(MY0) FINAL MONITORING REPORT - *Stream Mitigation*

STRAWBERRY HILL MITIGATION PROJECT

NCDMS Project #100094

**RE: DMS Comments on the Draft As-Built Baseline Monitoring Report
Strawberry Hill, Project ID #100094, DMS Contract #0007745**

Figure 2a
Current Conditions Plan View
Stream Mitigation
 MY0 2022
Strawberry Hill
Mitigation Project
 Johnston County,
 North Carolina

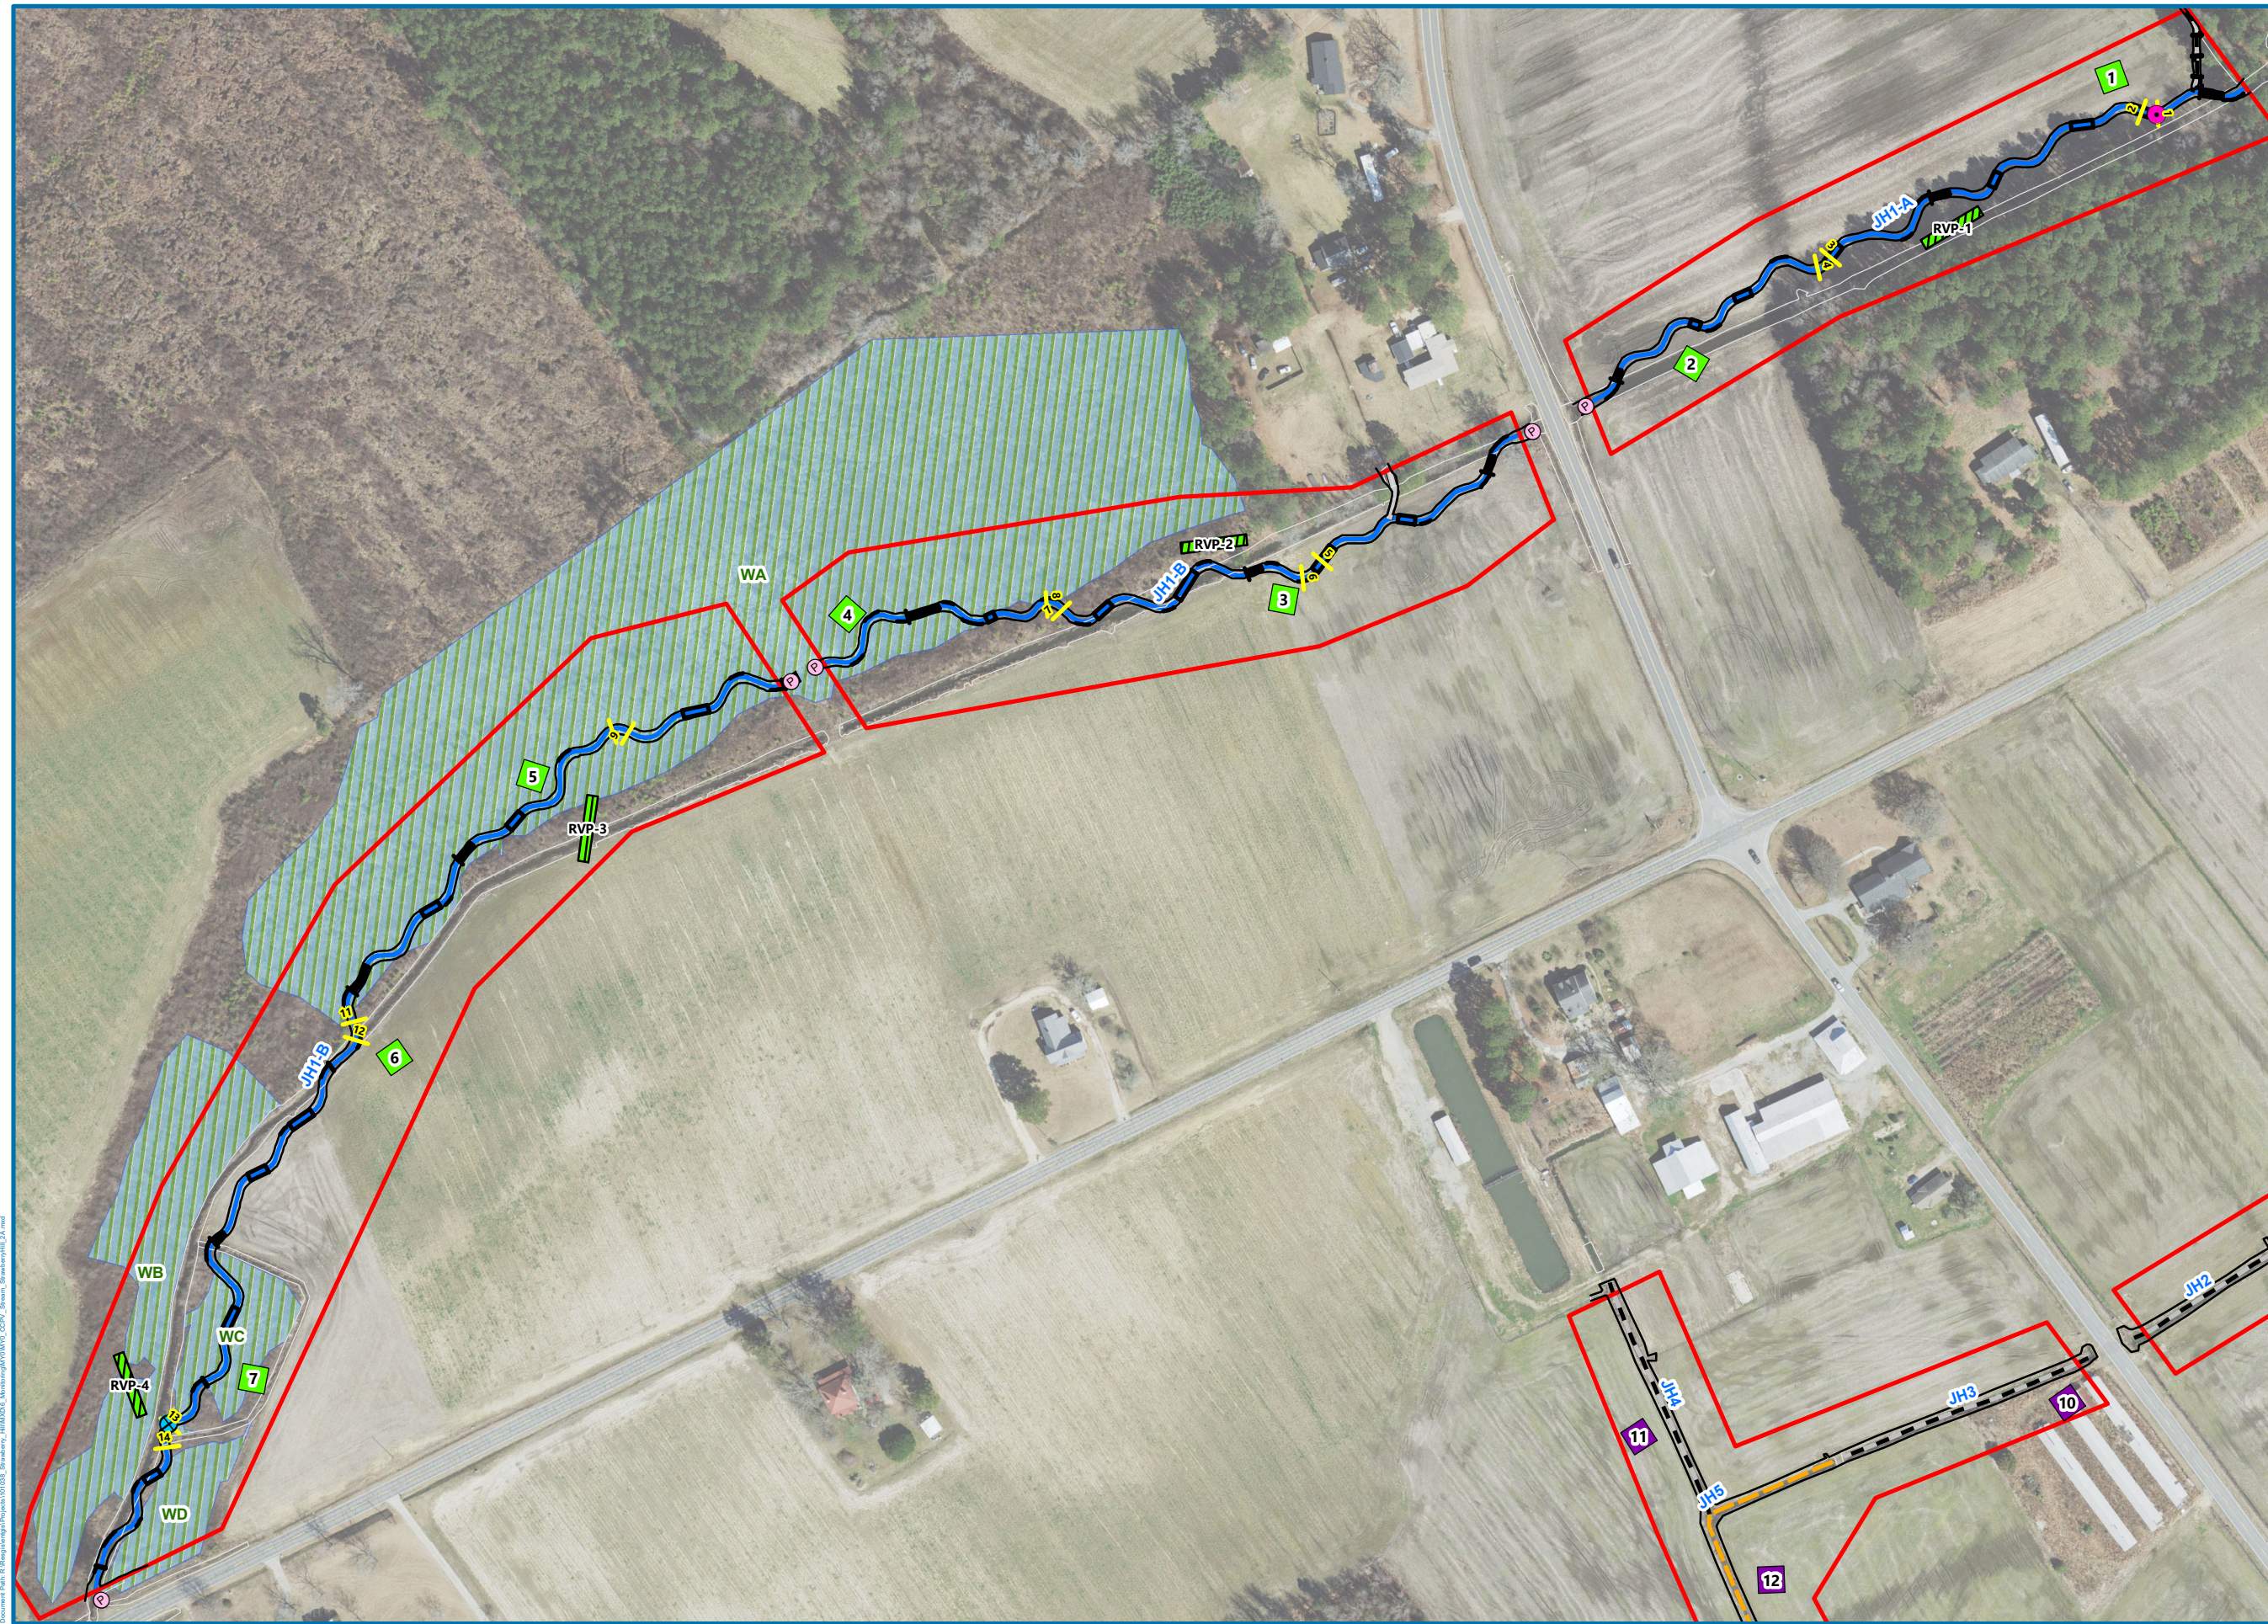
1. It is not possible to ensure the easement is accurate when compared to the CCPV in the stream asset baseline report, the CCPV does include the entire easement. The digital easement submitted does represent the DMS recorded easement. A requirement of the CCPV is to include the easement boundary, please revise the CCPV in the Stream Baseline Report to include the entire easement boundary. It is complete in the Buffer Baseline Report.
Figure 2 has been divided into Figure 2a and 2b so that monitoring devices are legible on 2a and the entire conservation easement is visible on 2b.
